Request for Proposal - ADDENDUM No. 6

PROJECT NAME & NO.: Government Solar Development Project SPVPP04

RE: Government Solar Development Project Q&A Round#3 /Document Updates

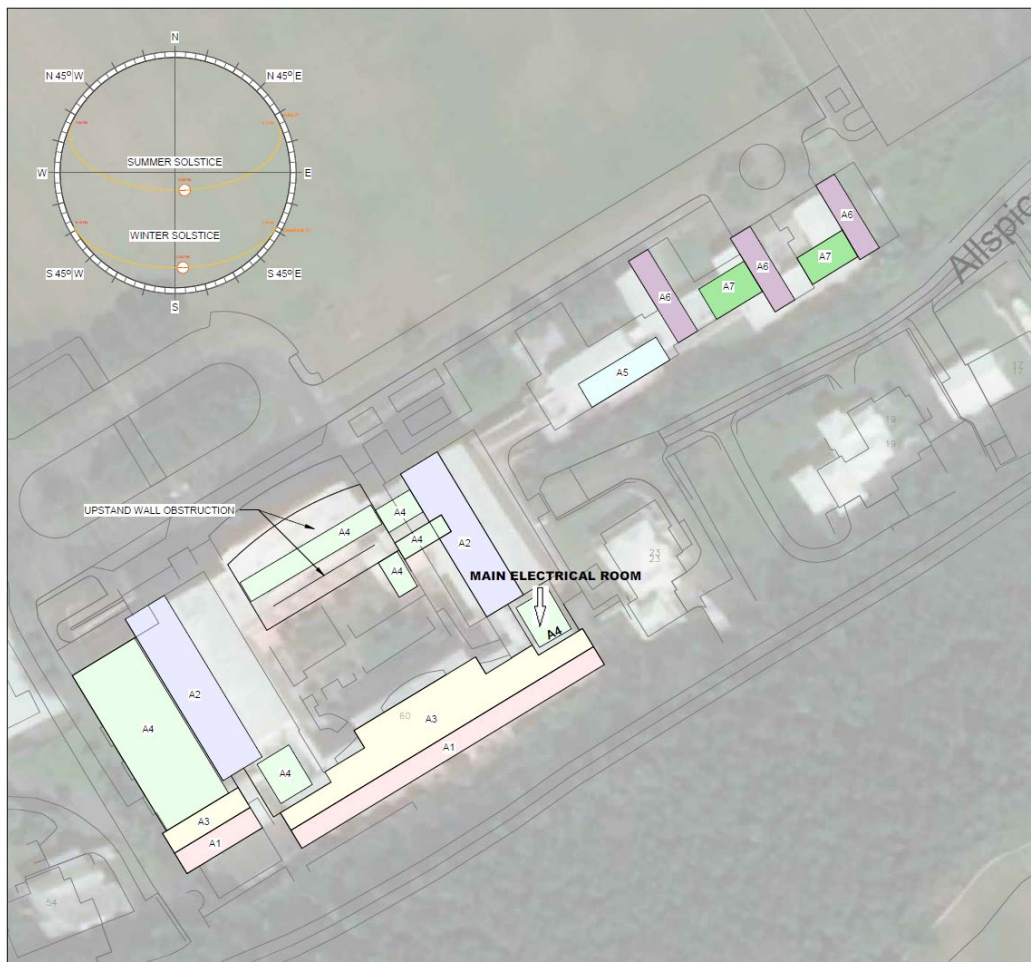
Q125. Please clarify if the multiple electrical rooms at the below sites are linked or whether the solar systems will need to be independent? Further, please indicate where the main transformer is located at this site with voltage characteristics and power (Kva):

A125.

- **C202 (MPW Quarry Depot)** – buildings on this site are separately metered and solar systems will need to be independent depending on nearest connection. Main transformer room was not accessed but the electrical room at recycling plant has 800kVa 4160V to 480V.
- **C206 (West Gate Correctional Facility)** - has a primary electrical room (next to entrance and backup generator) and two electrical rooms in the main building. Voltages are noted.
- **C208 (Cedarbridge Academy)** - fed from the main electrical building to the two HV electrical rooms. Voltages are noted.
- **C209: (Dellwood Middle School)** Please also confirm if the second electrical room is linked to the main room? Please use information provided and assume connected until tested/investigated otherwise.

- **C210 (Sandy's Secondary Middle School)** - the two electrical rooms on this site are not linked (separately metered).
- **C211 (West Pembroke Primary School)** - secondary electrical room is understood to be fed from Main Electrical Room as noted.
- **C212 (Hamilton Health Clinic and Annex)** - Annex Electrical Room functions as the main room and sub feeds the Health Clinic Electrical Room. Existing BELCO vault is adjacent to the Annex Electrical Room. Vault is next to the Annex Electrical Room and contains (3) 75kVA pole-mount transformers for a total capacity of 225kVA. Service voltage is 120/208V. There is a 600A disconnect switch located in the Annex Main Electrical Room acting as the service switch.
- **C234:(East End Primary School) Please confirm operating voltage?** Noted on drawing (120/240V). Note the three separate meters.
